Access Compliance Report

Public Rights-of-Way

(Curb Ramps)

Intersection ID: 45221	Main Street: HARCOMBE_DR	Cross Street: LISSADELL_CR	Location: NE
ADA ID: 3AED4F255E1B	Ramp Type: PerpDiag	Initial Pass/Fail: Fail	Overall Compliance: No
Severity Score: 25			
Codes/Mitigation Info/Possible Solution		Field Measurements/Component Compliance

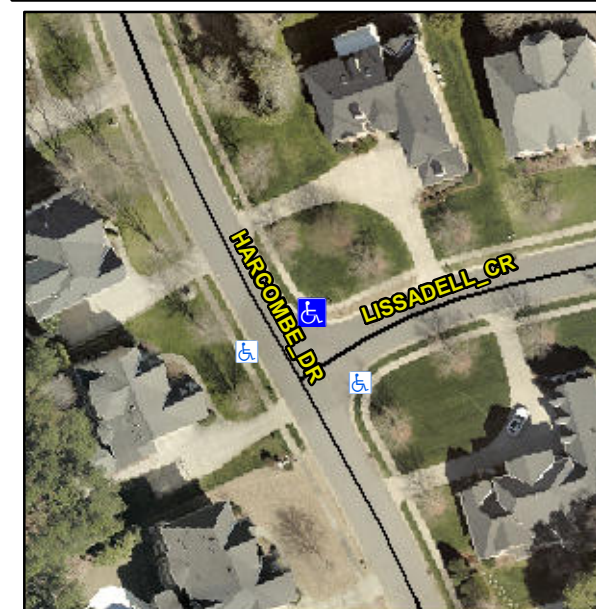
Not Found, R304.5.3

Compliance	Description	Data	Compliance	Description	Data
N/A	Ramp Length (in)	45.5	Yes	Ramp Slope (%)	8.0
Yes	Ramp Width (in)	50.5	No	Ramp XSlope (%)	11.2
N/A	Flare Type LT	N/A	N/A	Flare Type RT	N/A
N/A	Flare Slope LT (%)	N/A	N/A	Flare Slope RT (%)	N/A
N/A	Flare Traversable LT?	N/A	N/A	Flare Traversable RT?	N/A
N/A	Landing Length (in)	N/A	N/A	DWS Provided?	N/A
N/A	Landing Width (in)	N/A	N/A	DWS Contrast?	N/A
N/A	Landing Slope (%)	N/A	N/A	DWS Length (in)	N/A
N/A	Landing X Slope (%)	N/A	N/A	DWS Full Width?	N/A
N/A	Landing Curb? (Y/N)	N/A	N/A	DWS Offset (in)	N/A
N/A	Shared Landing?	N/A			
N/A	Gutter Ponding?	N/A	N/A	Gutter Slope (%)	N/A
N/A	Gutter Lip Ht (in)	N/A	N/A	Gutter X Slope (%)	N/A
N/A	Painted X Walk1?	No	N/A	Painted X Walk2?	No
	X Walk 1 Direction	To SW		X Walk 2 Direction	To SE
N/A	X Walk 1 Width (in)	N/A	N/A	X Walk 2 Width (in)	N/A
	X Walk 1 Slope (%)	0.3		X Walk 2 Slope (%)	6.7
	X Walk 1 X Slope (%)	7.5		X Walk 2 X Slope (%)	1.4

Remove & Replace Curb Ramp With Two New Directional Ramps or Equivalent.
